**SHOP DRAWING REVIEW**

<p>40 IDX Drive Building 100, Suite 200 South Burlington, VT 05403 802.497.6100</p>	<p>Job Number: BRF 025-1(42) Reviewed By: E.F. LAWES Date: MARCH 9, 2017</p>
---	--

COLD RIVER BRIDGES, LLC	
10 LANBRO LANE WALPOLE, NH	
TEL 603-756-9300	FAX 603-756-9303
LUDLOW BRF 0251(42)	
ABUTMENT #2 PLAN	SHEET NUMBER
DATE: 11/18/16	4

### ABUTMENT 2 PLAN

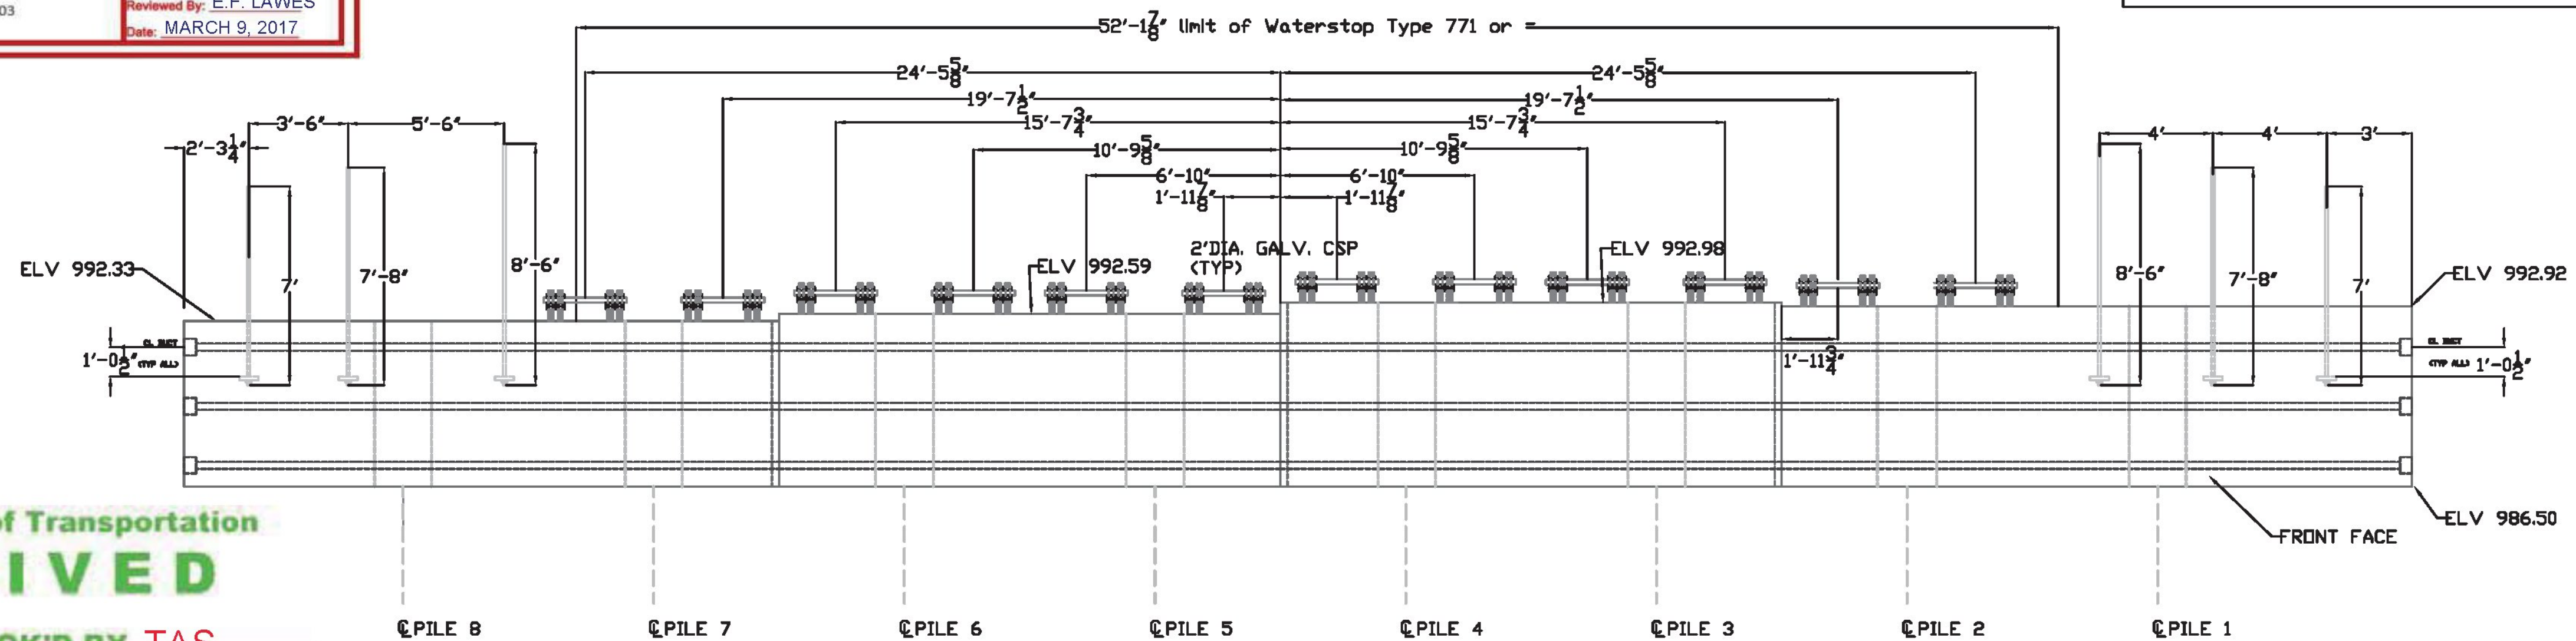
15" CLEAR BETWEEN PILE CAVITY AND ANCHOR BOLTS AS SHOWN. VERIFIED IN FIELD 15" CLEARANCE. EXTRA CARE SHALL BE TAKEN TO ENSURE CONCRETE CONSOLIDATION AROUND ANCHOR BOLT
